1 APPLICATION SUMMARY

Application information		
Address	28 Eastridge Street, Stapylton	
Lot and plan	Lot 117 SP316137	
Site area	4,094m ²	
Type of development and proposed use	Warehouse	
Categories of development and assessment	Code	
Properly made date	26 October 2022	
Decision due date	31 March 2023	
Applicant and Applicant's consultancy team	Eastridge 117 Pty Ltd – (Applicant) Gassman Development Perspectives – (Planning Consultant) Two Clicks Design – (Designer)	
Owner details	Eastridge 117 Pty Ltd	
City Plan version	Not applicable	
Preliminary approval	M38 Industrial Place Code	
Zone / Precinct	Low impact industry, Future low impact industry precinct, Medium impact industry, Future medium impact industry, High impact industry.	
Overlays	Not applicable	
Submissions	Objections	Support
	Not applicable	Not applicable
Key matters raised by submitters	Not applicable	
Referral agencies	Not applicable	
Officer's recommendation	Approval with conditions

The purpose of this report is to assess an application for a development permit for a Material change of use to establish a Warehouse at 28 Eastridge Street, Stapylton.

Figure 8: Refuse storage area (Source: Two Clicks Design)

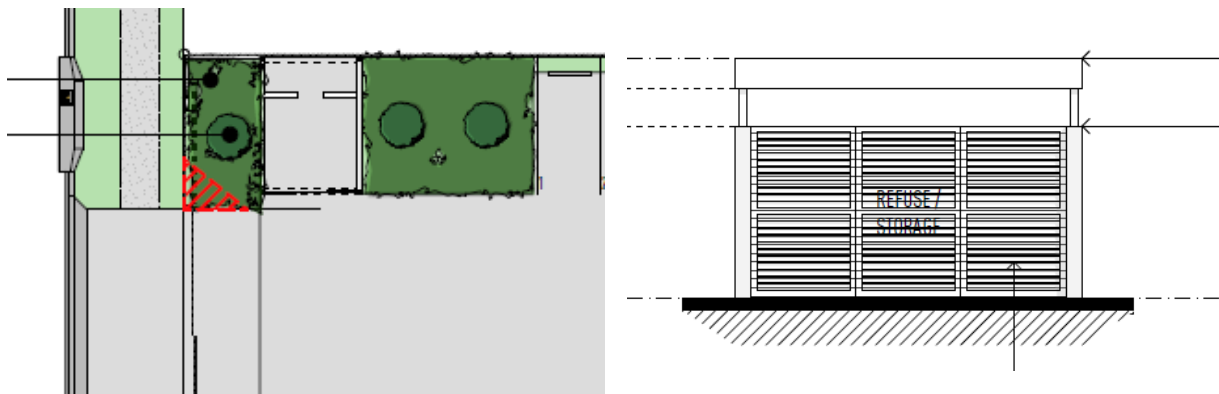
The proposed development includes a refuse shelter within 3 metres of the primary street frontage. As such, the proposed development cannot comply with Acceptable Solution AS4.2 and assessment is required against Performance Criteria PC4.

The proposed development provides refuse storage at the front of the site in lieu of providing a drive on / drive off waste removal provision within the site. The refuse shelter houses 2 x 2000 litre bins and a single 360 litre bin, which officers consider to be an appropriate size to allow the bins to be manually moved by the waste collection team or onsite staff.

The refuse storage area is screened from the street frontage by 3 metres of landscaping as identified in the image below. The storage shelter consists of 2.8 metre high roofed structure with a painted block wall orientated to the street with access to the refuse achieved through painted aluminium sliding doors to the side of the structure. With the provision of the frontage landscaping and the built form of the refuse shelter screening the bins from the view of the public realm, the encroachment of the refuse storage in the front setback is not considered have negative visual amenity impacts to the areas viewed by the public.

Based on the above assessment it is considered that the development complies with Performance Criteria PC4 of the M38 Industrial Estate Place Code.

Figure 9: Proposed SLI (Source: Two Clicks Design)

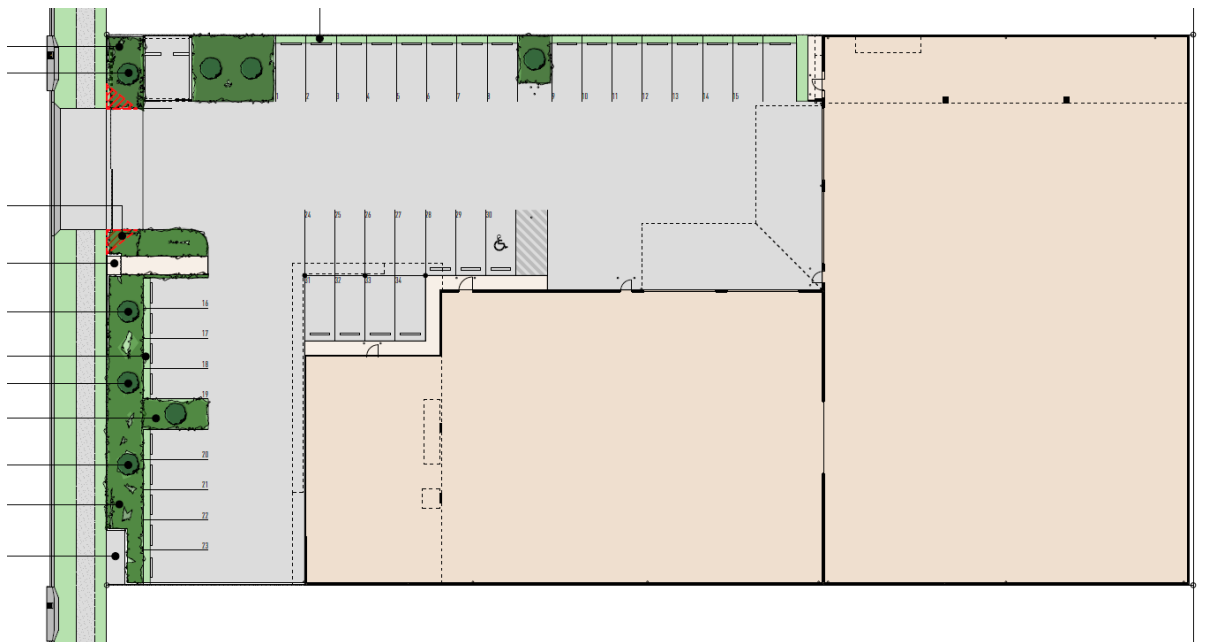
The proposed development provides a reduced frontage landscaping with a minimum garden width of 1.5 metres due to the location of the water metre easement. The remainder of the frontage landscaping provides a width of 3 metres and does not achieve 5 metres of planting width for 25% of the frontage. As such compliance with Acceptable Solution AS25.1 cannot be achieved and assessment has been provided against the applicable Performance Criteria PC25 requirements.

In order to assist in demonstrating compliance with the applicable Performance Criteria, the landscape design must enhance the landscape character of the Yatala Enterprise Area. To assist demonstrating the desired landscape enhancement, a sufficient landscape buffer is recommended to be provided capable of supporting a combination of large canopy trees and screening shrub planting. The vegetation is recommended to remain unobscured (by any proposed fencing) when viewing the subject site from the adjoining public road reserve.

The proposed frontage landscape buffer varies from 1.5 metres to 3 metres in width along the front boundary. The 1.5 metre width section is limited to the 4.5 metre wide water metre location at the front boundary. The proposed 3 metre wide garden bed is considered to be of an acceptable size to support canopy trees and screening shrub plantings within the frontage to assist enhancement of the local landscape character. As reflected in Figure 9 below, the submitted Statement of Landscape Intent (SLI) is considered to reflect appropriate landscaping area to support tree planting within the frontage. Council officers recommend imposing conditions requiring large canopy tree planting to be provided at appropriate centres (6 metres) with associated accent planting to assist demonstrating compliance with the applicable Performance Criteria.

Based on the above assessment it is considered the development complies with Performance Criteria PC25 of the M38 Industrial Estate Place Code.

Figure 10: Proposed swept path and servicing areas (Source: Two Clicks Design)

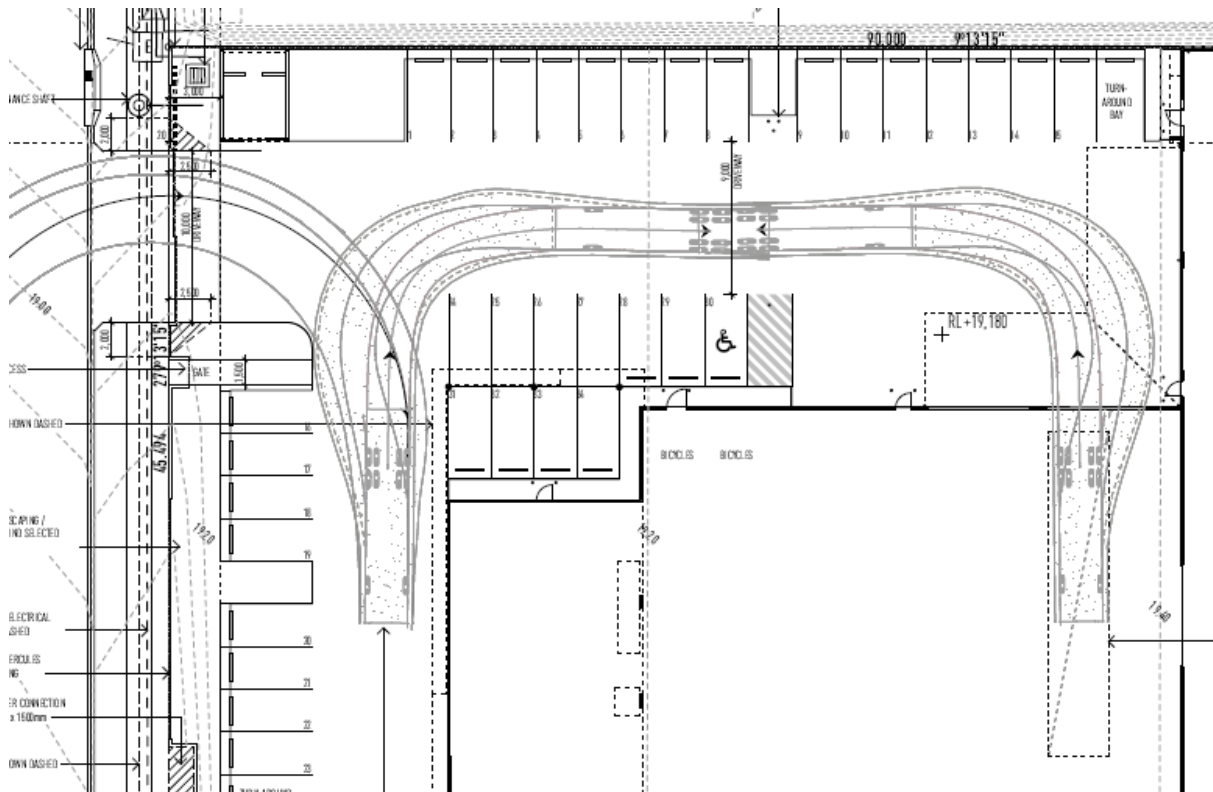
The proposed development provides a service bay for a Heavy Rigid Vehicle (HRV) but due to spatial limitations within the site and the built form, a formal service bay cannot be established for an Articulated Vehicle (AV). As such compliance cannot be achieved with Acceptable Solution 14.1 and assessment is required against Performance Criteria PC14.

The proposed Warehouse development includes an internal service bay for loading and unloading of HRVs. Submitted plans annotated a service bay within the Warehouse to accommodate an AV. Assessment of the vehicle swept paths has determined that an AV is unable to access the internal service bay (figure 10). Table to Acceptable Solution AS14.1 indicates that Industry uses established on a site exceeding 4,000m² are to accommodate AVs.

Given that the area of the subject site only exceeds the 4,000m² requirement by 94m², in the case of this development officers accept that AVs can load / unload within the parking aisle on site. As the proposed plans have nominated an AV service bay, officers have recommended a condition of approval amending the service bay to the dimensions of a HRV.
